Entergy Operations, Inc.
1340 Echelon Parkway
Jackson, MS 39213

G3NO-2008-00020

SUBJECT: Responses to NRC Requests for Additional Information, Letter No. 14
(GG3 COLA)

REFERENCE: NRC Letter to Entergy Nuclear, *Request for Additional Information
Letter No. 14 Related to the SRP Section 09.02.01 for the Grand Gulf
Combined License Application*, dated October 24, 2008 (ADAMS
Accession No. ML082960046).

Figure 2.4.2-201.
PLANT SERVICE WATER COOLING TOWER AND BASIN
FUNCTIONAL ARRANGEMENT

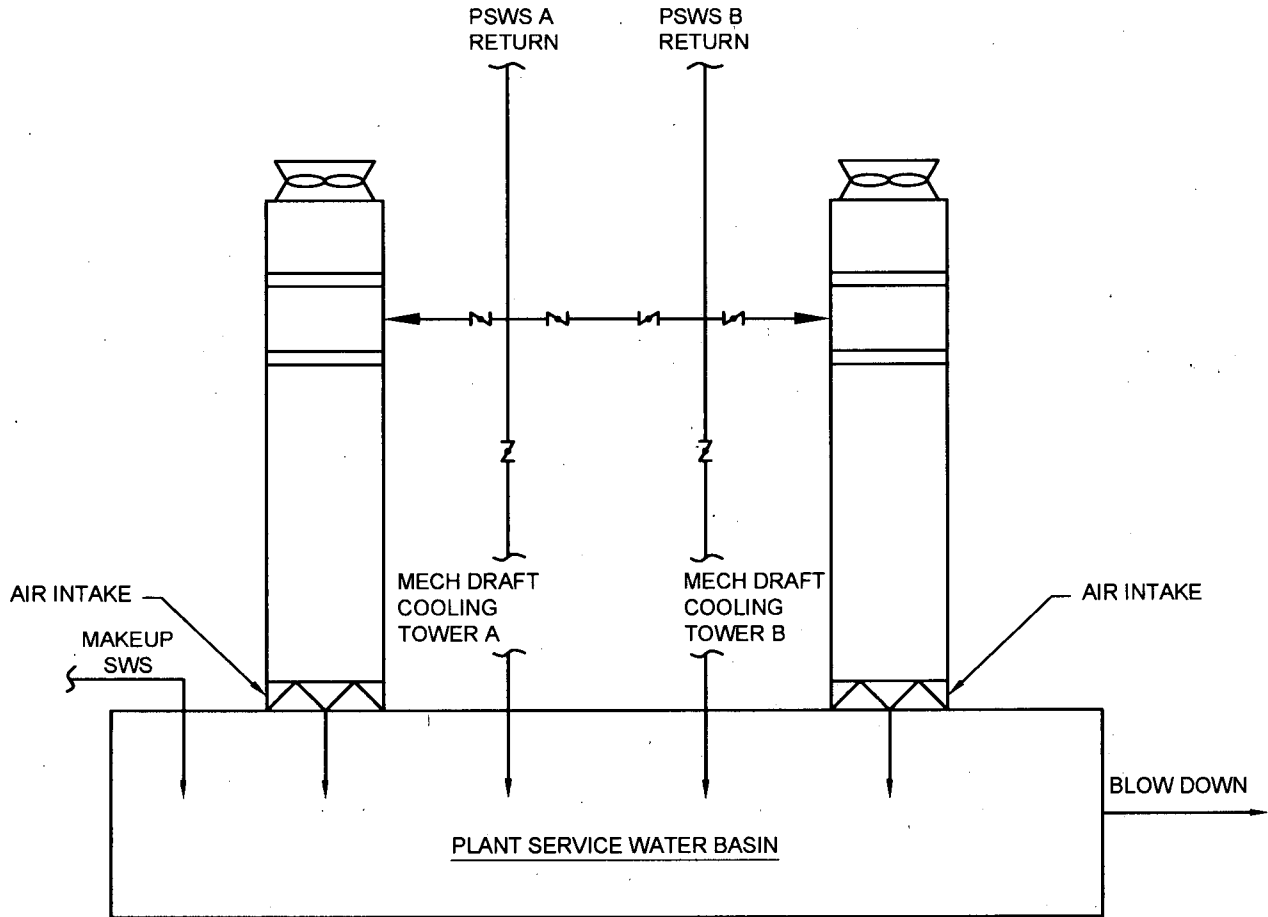
Tier 1 of the ESBWR DCD, Section 4.1, specifies as a COL interface requirement that the plant-specific Plant Service Water System (PSWS) be capable of removing 2.02×10^7 MJ (1.92×10^{10} BTU) over a period of seven days without active makeup. The proposed Inspections, Tests, Analyses, and Acceptance Criteria (ITAAC) specify a cooling tower basin water inventory requirement as a way of demonstrating that the heat removal capability specified by the DCD has been satisfied. While water inventory is an important factor that must be addressed by the ITAAC, it does not demonstrate that the cooling towers are capable of dissipating the specified heat load. The capability of cooling towers to dissipate heat is dependent upon a number of other factors that should be taken into consideration, such as cooling tower design attributes; the capability to satisfy the PSWS pump minimum net positive suction head (NPSH) requirements for the most limiting cooling tower basin water level, temperature, and flow conditions; the maximum allowed PSWS water supply temperature; and the most limiting meteorological assumptions that pertain to the site for determining: (a) heat dissipation capability, and (b) water inventory requirements. Transient analyses that take these factors into consideration (including margin for expected degradation and operating flexibility) and confirmatory testing are usually necessary in order to adequately demonstrate that cooling tower performance satisfies the specified heat removal requirement. Also, the extent and basis for using the combined normal power heat sink (NPHS) and auxiliary heat sink (AHS) cooling tower basin inventories for Trains A and B were not described. Additional information is needed to address consideration of these factors such that the specified cooling tower performance capability is adequately demonstrated for both defense-in-depth and regulatory treatment of non-safety systems (RTNSS) functions, and the Final Safety Analysis Report (FSAR) and ITAAC need to be revised accordingly to describe the plant licensing basis in this regard.

Part 10, ITAAC Section 2.4.2 will be revised as indicated in the attached draft markup to include additional ITAAC related to the functional arrangement and functionality of the PSWS cooling towers, and to revise the PSWS cooling tower basin inventory volume to 2.6×10^6 gallons.

To support the functional arrangement ITAAC, Part 10, Figure 2.4.2-201 will also be added.

Figure 9.2-203. Station Water System Simplified Diagram

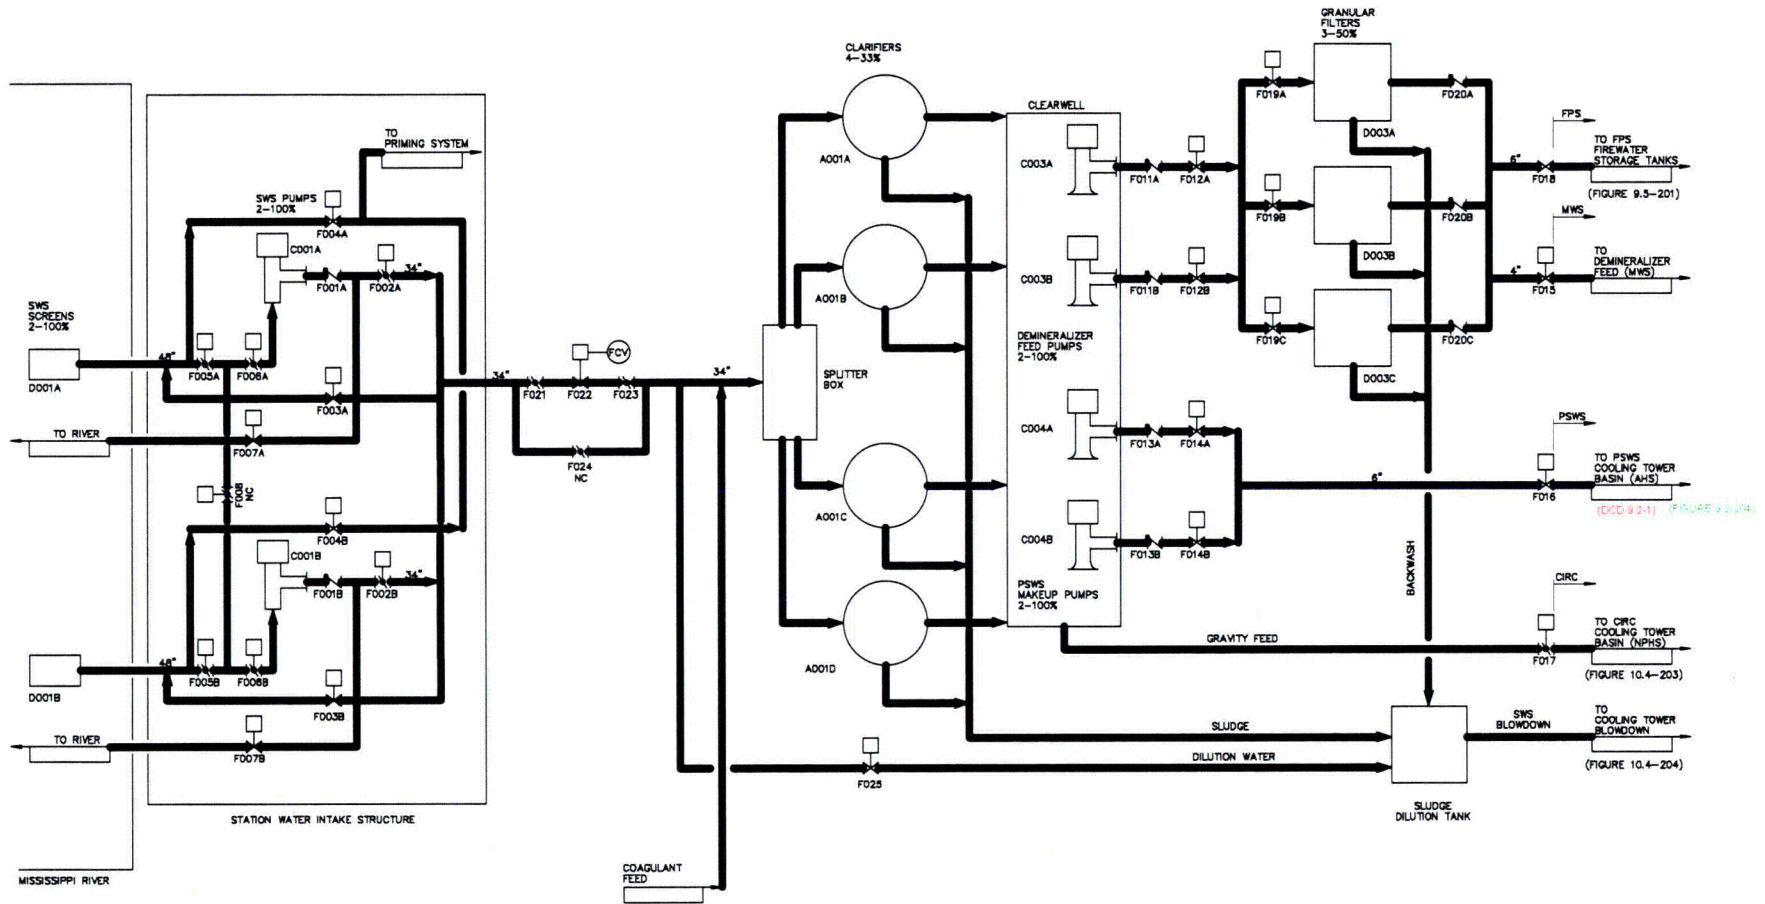
Section 9.2.1.2 (under Operation) specifies that "during normal power operation, plant service water system (PSWS) flow is directed to the normal plant heat sink (NPHS) cooling tower where heat removed from the reactor component cooling water system (RCCWS) and Turbine Component Cooling Water System (TCCWS) is rejected to the NPHS. During this mode of operation, the NPHS basin provides makeup to the alternate heat sink (AHS) basin. During other modes of power operation, PSWS flow is directed to the AHS cooling tower where heat removed from the RCCWS and TCCWS is rejected to the AHS. During this mode of operation, makeup to the AHS basin is provided from the Station Water System (SWS)". While this supplemental information explains how makeup is provided to the AHS depending on how the PSWS is aligned for heat rejection, it is not clear what the different "modes" of power operation are. This is especially confusing because the term "mode" has a specific meaning in the Technical Specifications, and specific modes of power operation are not assigned for when the NPHS or the AHS should be used. The FSAR needs to be revised to eliminate this confusion and to better explain when the NPHS vs. the AHS will be used for various operating, transient, and accident conditions.

FSAR Sections 1.2.2.12.7, 9.2.1.2, and 10.4.5.8, FSAR Tables 1.7-202, 1.8-203, and 10.4-3R and FSAR Figures 9.2-203, 10.4-203 and 10.4-204 will be revised as shown in the attached draft markups. In addition, an FSAR figure is being added, FSAR Figure 9.2-204.
